# Addendum No. 1

## CSI Diesel Mechanics Facility

## Addendum 1

Project: CSI: Automotive/Agricultural Diesel Mechanics Facility

**CANAL PIPING PLAN & PROFILE**

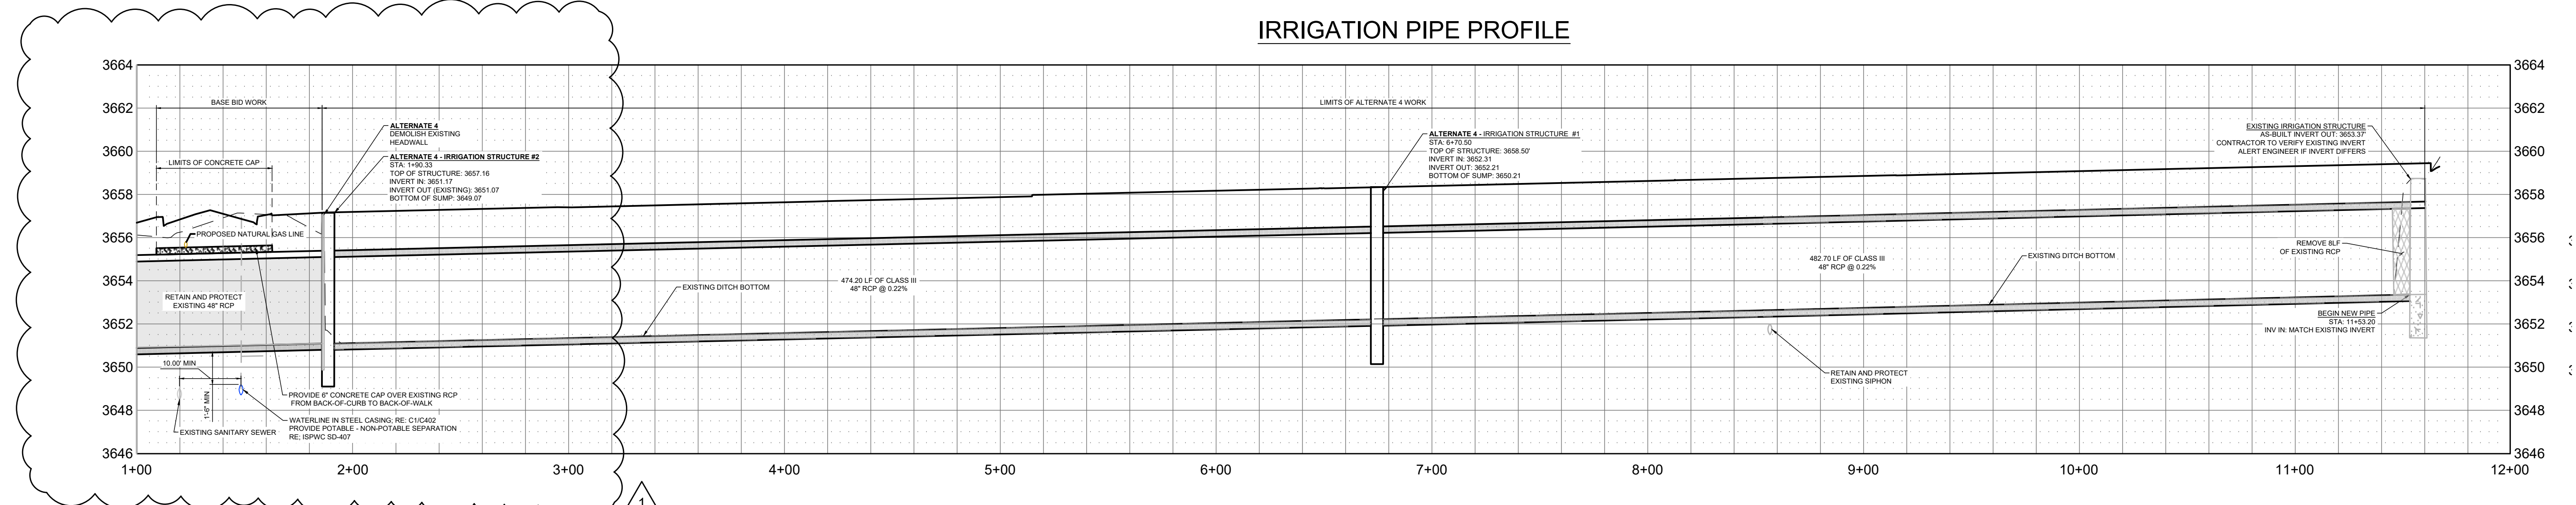
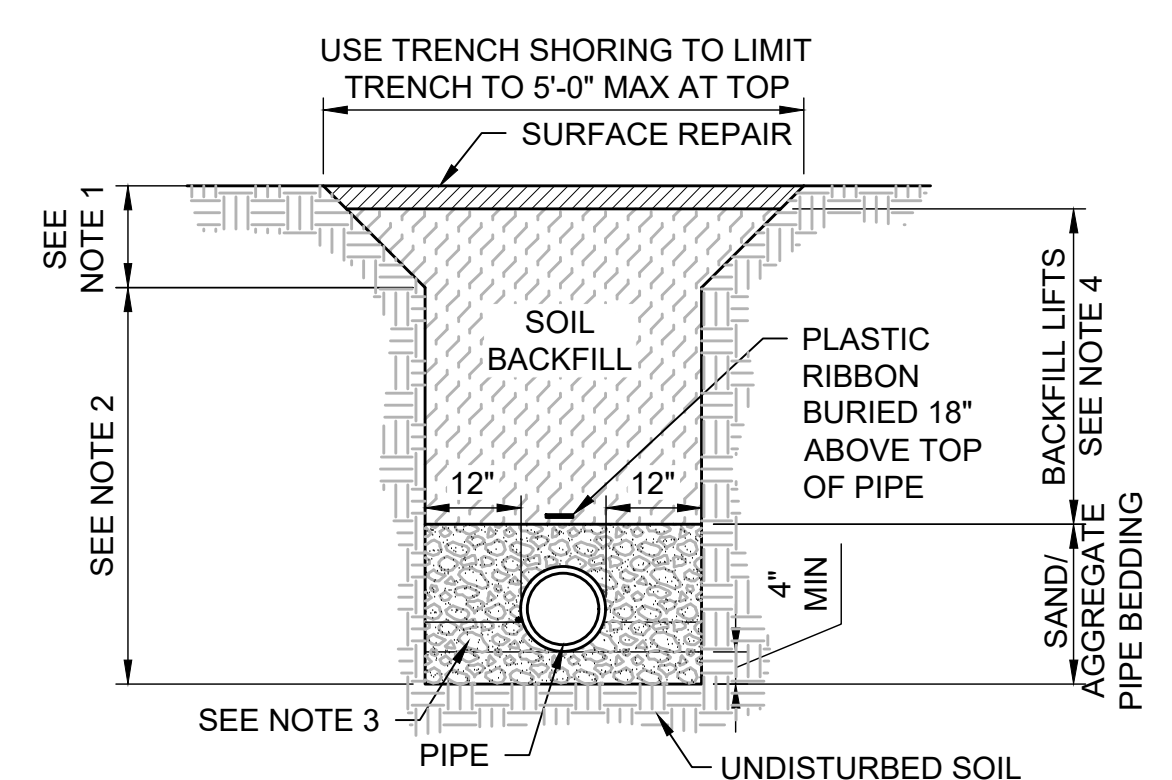
Add. #1 Plan and profile updated to retain existing RCP crossing under new ring road.

A1 N COLLEGE ROAD TYPICAL SECTION  
N.T.S.

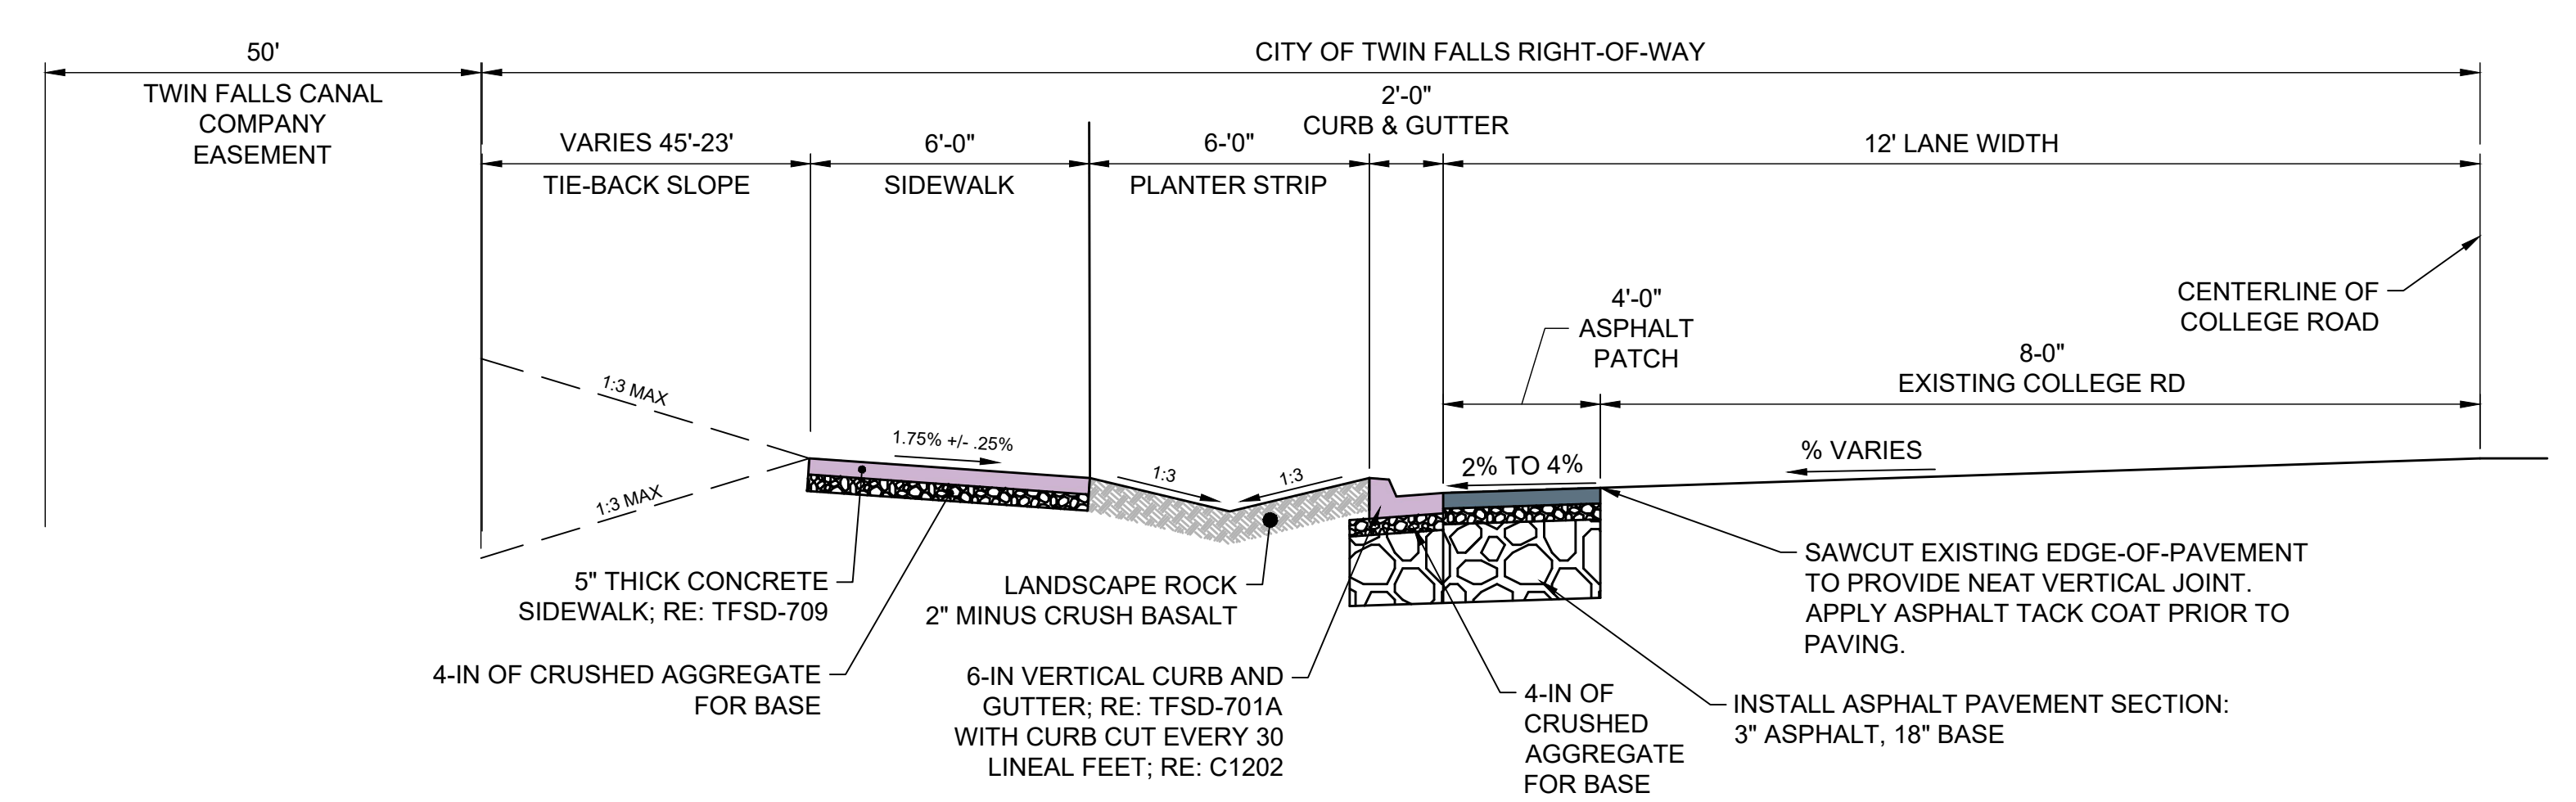
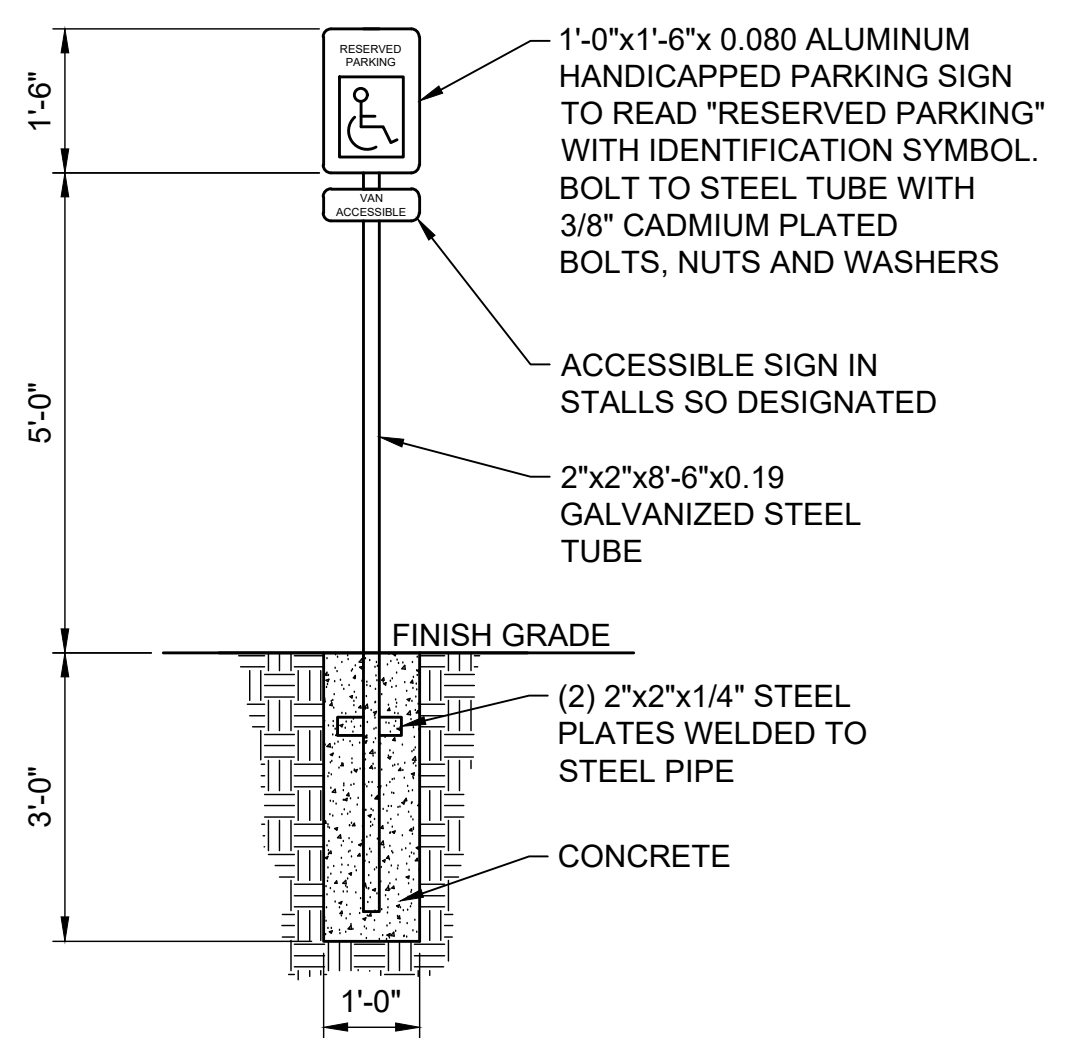
Add. #1 Updated to include city frontage improvements typical section and typical rolled curb details.
